Technical product information

Topic	Rear seat entertainment - Crosslink feature unavailable
Market area	Russische Föderation (5RU),Australia E04 Bentley rest Asia and Australia (6E04),China 796 VW Import Comp. Ltd (Vico), Beijing (6796),Germany E02 Bentley rest Europe (6E02),Japan E03 Bentley Japan (6E03),Korea, (South) E08 Bentley South Korea (6E08),United Arab Emirates E06 Bentley Middle East and Africa (6E06),United Kingdom E01 Bentley UK (6E01),United States E05 Bentley USA and rest America (6E05)
Brand	Bentley
Transaction No.	2069414/1
Level	EH
Status	Approval
Release date

New Flying Spur and Bentayga Series

Figure 1

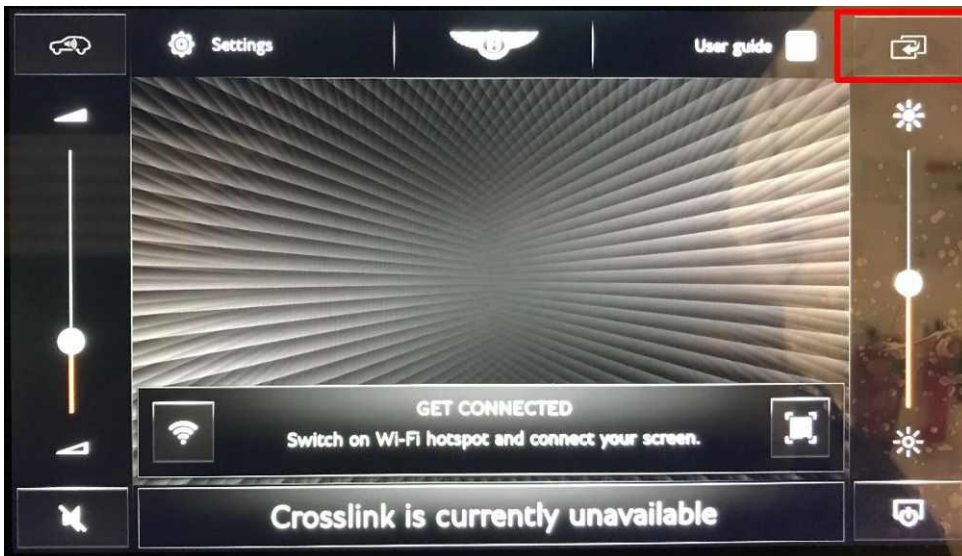
The 'crosslink' function and icon within the Rear Seat Entertainment screens (RSE) is no longer available (Figure 1)

Figure 2

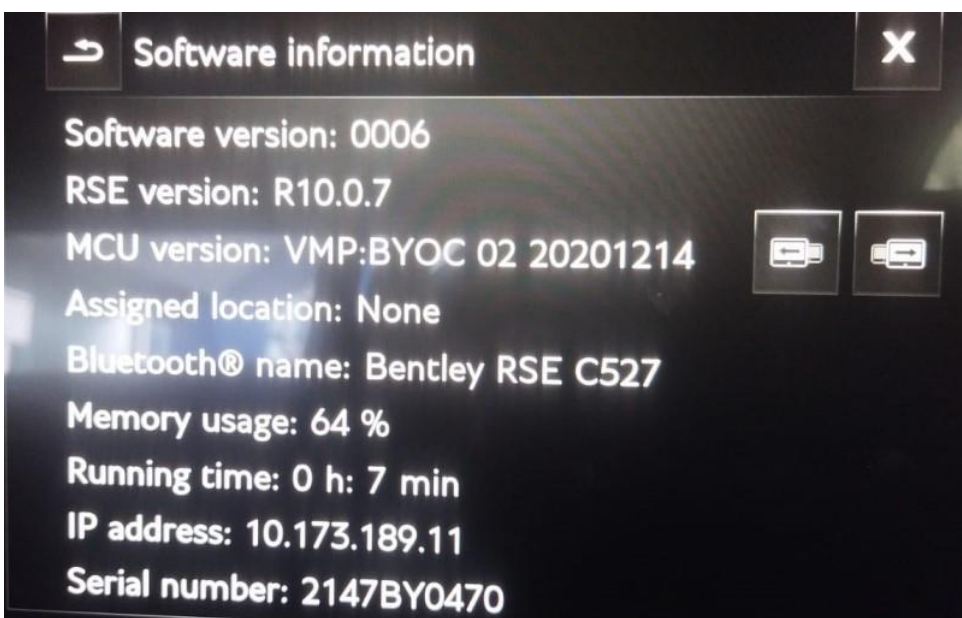
The 'crosslink' function and icon will no longer be available/visible post RSE version: R10.0.7 (Figure 2)

The deletion of the 'crosslink' function would be conducted automatically via an over the air update
 No further work or diagnosis is required
